Gladesville Bridge Marina Refurbishment Project Acid Sulfate Risk Assessment and Construction Management Plan

1 COUNCIL REQUEST

Figure 1 Portion of CBLEP 2013 ASS Map Sheet 006

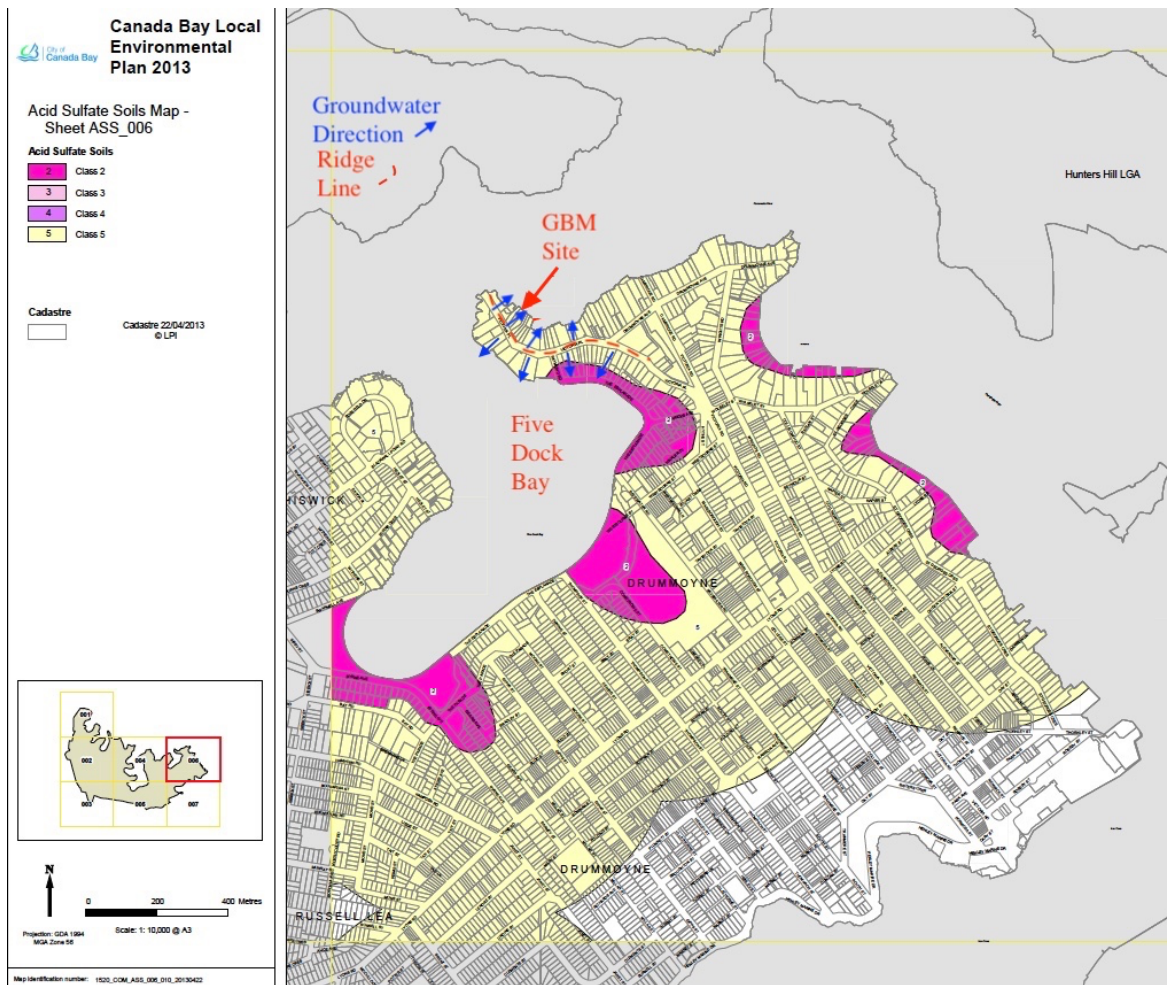
As part of its DA preliminary assessment, Canada Bay Council requested further information regarding the EIS Part 2.3 statement that "acid sulfate soils are not anticipated within the development areas on land or on the water" and enquired whether an acid sulfate soil plan would be required for the construction works. The following sets out the Canada Bay LEP 2013(CBLEP) requirements, reviews the proposal and addresses this issue.

CBLEP Clause 6.1 (2) states that Development Consent is required for the carrying out of works described in the Table to this subclause on land shown on the Acid Sulfate Soil Maps as being of the class specified for those works. The LEP Acid Sulfate Soils Map (Sheet ASS_006 - see Figure 1 below) indicates the site to be Class 5 and as per this clause Development Consent is required for Works on Class 5 lands that *are within 500 metres of adjacent Class 1, 2, 3 or 4 land that is below 5 metres Australian Height Datum and by which the water table is likely to be lowered below 1 metre Australian Height Datum on adjacent Class 1, 2, 3 or 4 land.*

Whilst the subject site is within 500 m of class 2 lands below 5m AHD (south along the foreshore of Five Dock Bay at The Esplanade), those lands are on the other side of the Victoria Place Ridge line to the Marina site, with ground water flow generally flowing downslope from this ridge line; i.e., south to Five Dock Bay and north to Parramatta River. Therefore, there is no interaction between the site and the water table under Class 2 lands to the south so Clause 6.1(2) does not apply.
